Attachment to July 18th, 2014
10 C.F.R. 2.206 Enforcement Petition
Florida Power & Light Company
Turkey Point Nuclear Plant

Letter from the Florida Power & Light Co. to the NRC dated July 22nd, 2014 -
Response to Request for Additional Information Regarding License Amendment
Request No. 231, Application to Revise Technical Specifications to Revise
Ultimate Heat Sink Temperature Limit (7-pages).

Subject: Response to Request for Additional Information Regarding License Amendment
Request No. 231, Application to Revise Technical Specifications to Revise Ultimate
Heat Sink Temperature Limit

Application to Revise Technical Specifications
To Revise Ultimate Heat Sink Temperature Limit

Time Series Temperature Plot

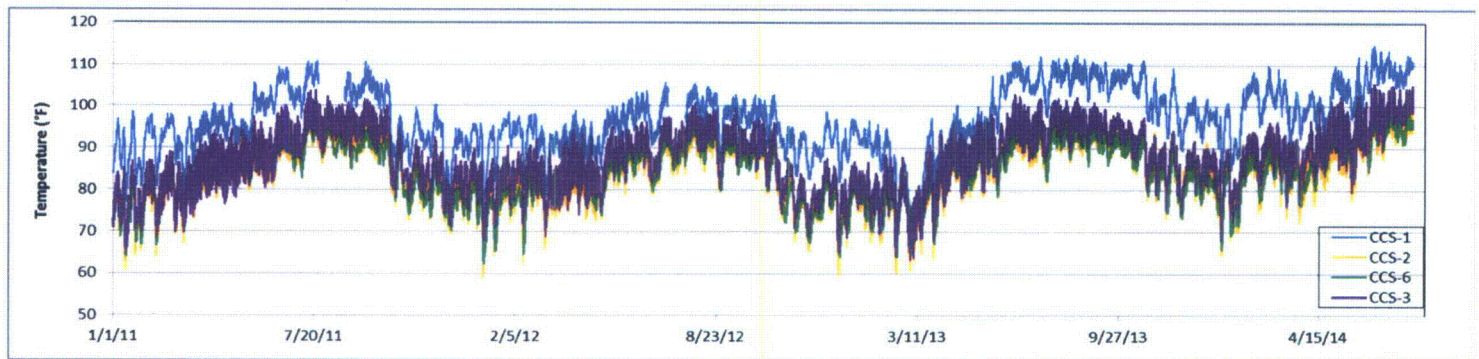
Provide an analysis of the impacts to crocodiles that would result from the temperature increase that addresses effects to crocodile growth, survival, abundance, and spatial distribution on the Turkey Point site. The analysis should also address any adverse modifications to designated critical habitat on the site. Both the direct impact of the LAR (i.e., increased cooling canal system temperatures) and any indirect impacts (e.g., increased salinity resulting from the increased evaporation rate of higher temperature water) should be addressed.

FPL has several stations that monitor temperature in the CCS on an hourly basis. Below is a time series temperature plot for 4 of those stations. The attached map identifies the station locations. Station CCS-3 is a station in the area that is utilized most by the crocodiles. The data indicates the temperature fluctuates throughout the year with temperature typically peaking in the month of July. The factor that restricts American crocodiles across their range is access to fresh water for their hatchlings to develop salt excreting glands. The Turkey Point Nuclear Power Plant Cooling Canal System is an ideal situation in order for the population to recruit more individuals. Within the CCS there are numerous fresh water and lower saline ponds where females place the hatchlings for the purpose of developing their salt excreting glands.
